ASSESSMENT REPORT

ORICA SOUTHLANDS PROJECT – BOTANY INDUSTRIAL ESTATE MP 06_0191 MOD 3

Figure 4: Approved layout of Warehouse A and proposed relocation and inclusion of changes shown in **red**

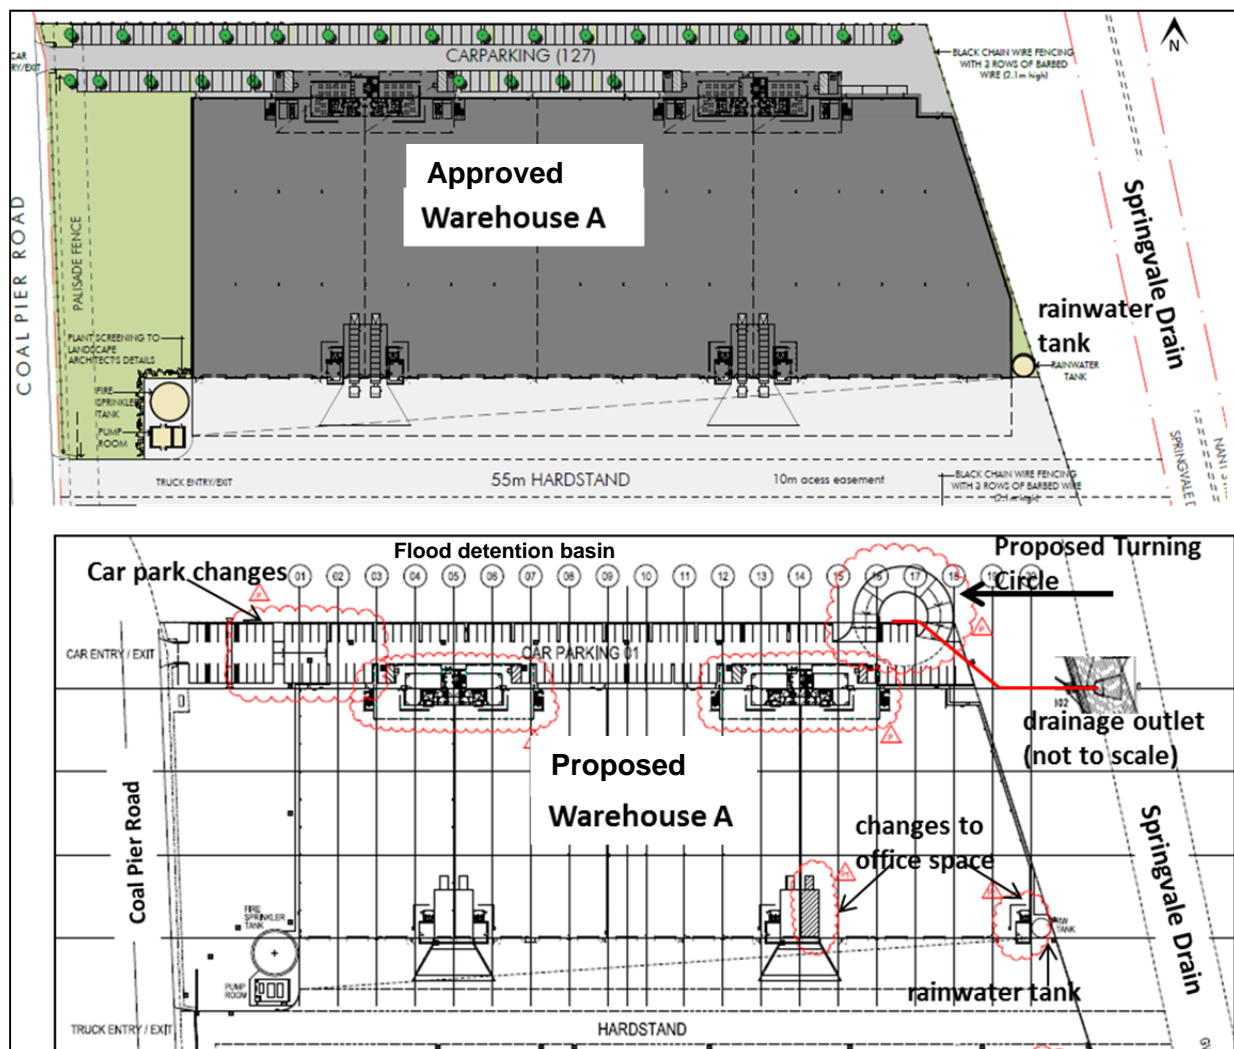
Warehouse A	Warehouse B
<ul style="list-style-type: none"> Inclusion of a turning circle at the north-eastern corner of the car park that would encroach into the flood detention basin. Additional drainage outlet to Springvale Drain and amendments to drainage layout underneath the proposed turning circle. Adjusting the car park layout for a new emergency vehicle turning circle which results in the reduction of 2 spaces (from 127 to 125 spaces). Minor relocation of rainwater tank. Removal of mezzanine storage area within the office space. Relocation of the internal dock office. 	<ul style="list-style-type: none"> Changes to the size and layout of office spaces including an increase of 40 sqm from the control tower office floor area (58 to 98 sqm). Relocation of the truck wash area and rainwater tank. Relocation of the LPG gas storage area including the addition of an awning structure for weather protection. A reduction of 2 car parking spaces (from 175 to 173 spaces).

Figure 6: Proposed location of facilities on the site of Warehouse B

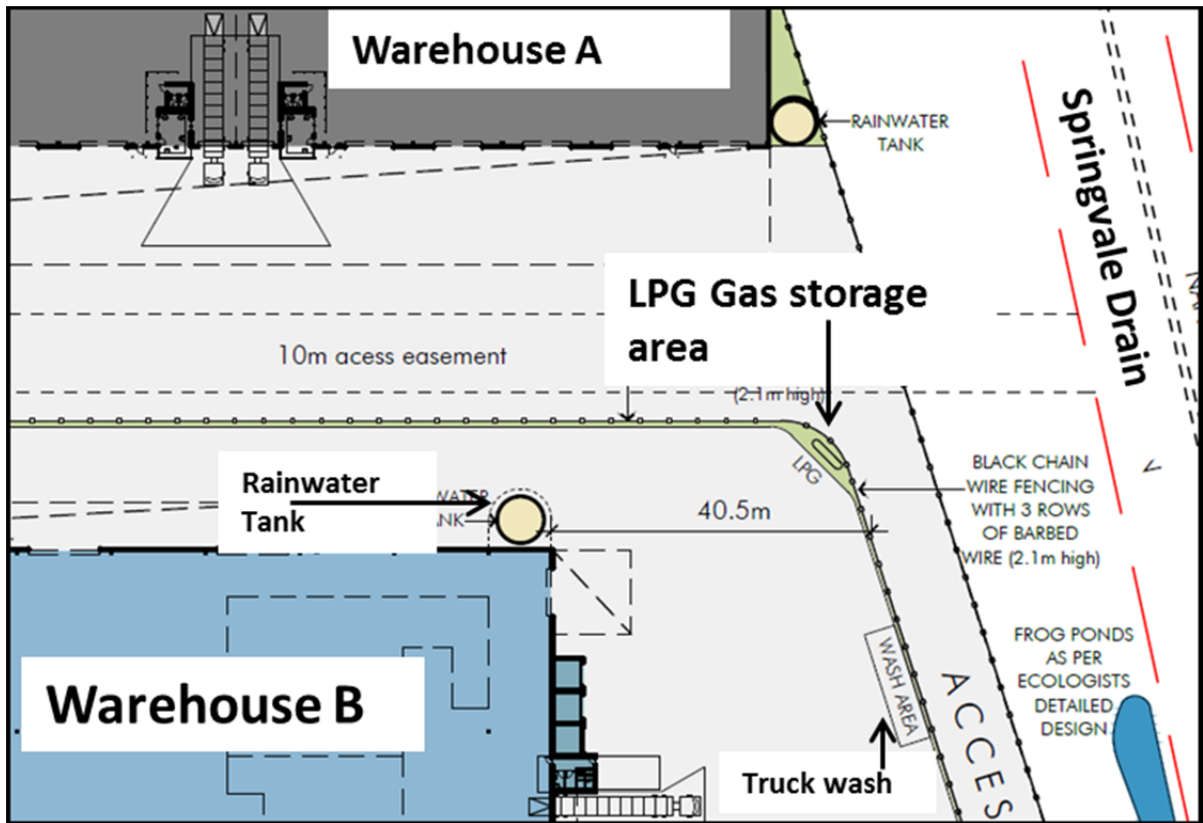
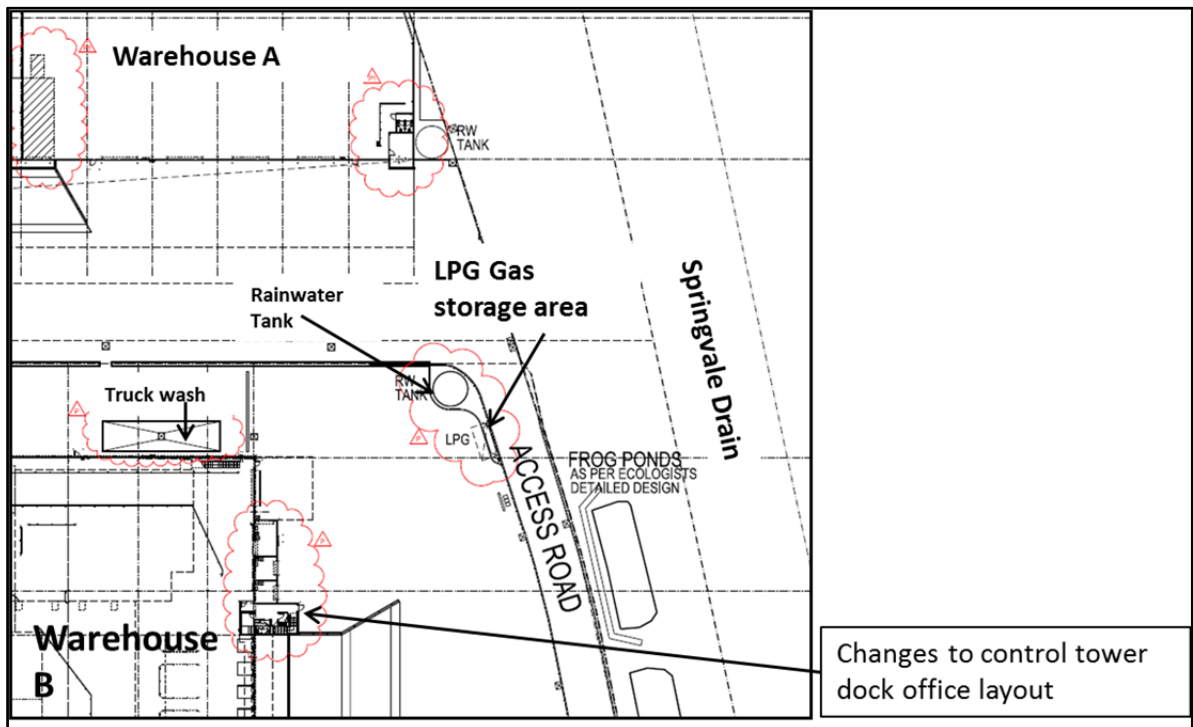
The physical changes proposed on the site of Warehouse A are shown in **Figure 4** and the changes proposed to Warehouse B are shown in **Figures 5 and 6**.

Figure 8: Proposed turning circle located in the approved flood detention basin (flood storage area)

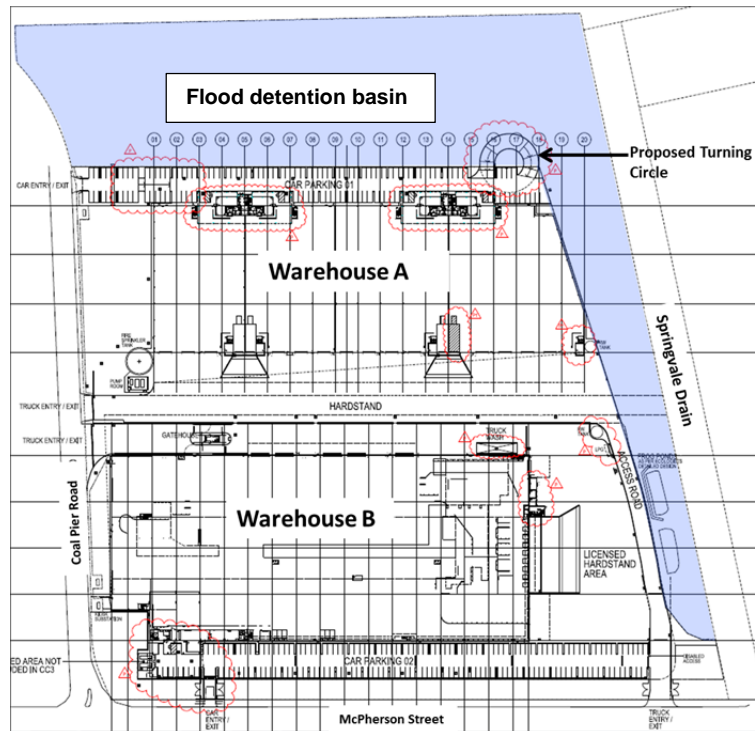
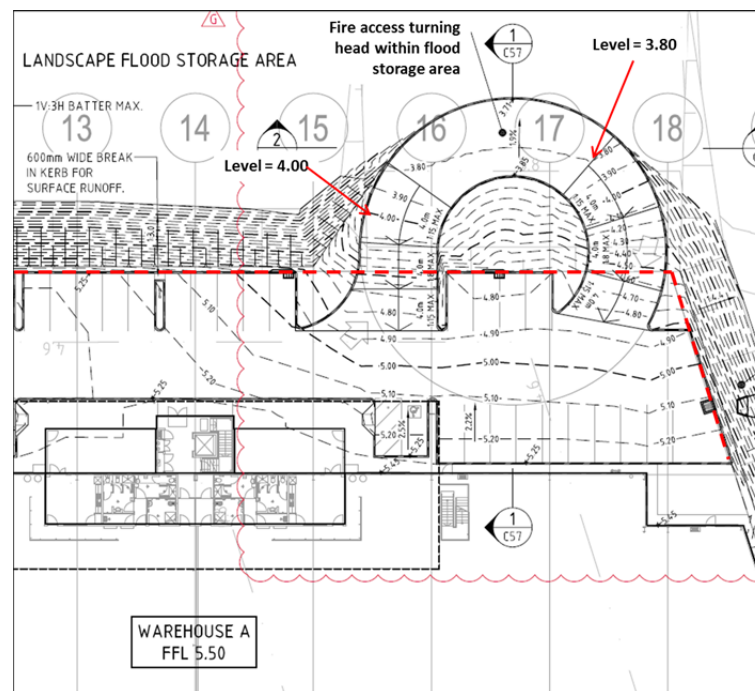
A truck turning circle with a radius of 14.7 metres is proposed to be located at the north eastern corner of the site. The turning circle is proposed in order to satisfy NSW Fire Service access requirements to ensure fire trucks have the ability to turnaround quickly on the site and exit safely in a forward direction. However, the turning circle would encroach into an approved flood detention basin (see **Figures 7 and 8**) and would potentially result in additional flooding impacts.

To address the potential flooding impacts associated with the proposal, the Proponent submitted a flood impact assessment prepared by Aurecon Australasia Pty Ltd (dated 28 August 2015). The assessment found the turning circle may result in some minor off site impacts within a range of 1-2mm. However, the assessment concluded these increases were the result of numerical instabilities in the flood modelling rather than from the proposed development, therefore the proposal would have negligible impact on flooding.

Council also raised concern with the level of the turning circle which varies between RL 3.8 metres and RL 4.6 metres. Council were concerned that the turning circle would not provide flood free access for emergency vehicles if it is constructed below RL 4.0 metres and requested a condition be incorporated which requires the finished level of the turning circle to be above RL 4.0 metres.

The Department is also of the view that the height of the turning circle is acceptable for emergency vehicle access at a height of RL 3.80 metres on the basis that:

- an increase in height would potentially cause unacceptable flood level increases;
- the probability of a fire at the time of a 1:100 year flood event is rare;
- flood depth warning signs would be provided, allowing fire services to make an informed decision regarding the use of the turning circle during a flood event; and
- emergency vehicles would still have access to the site during a flood event as fire trucks

are designed to traverse low level flood waters, and there is sufficient space in the car park to execute a three point turn without the need of the turning circle.
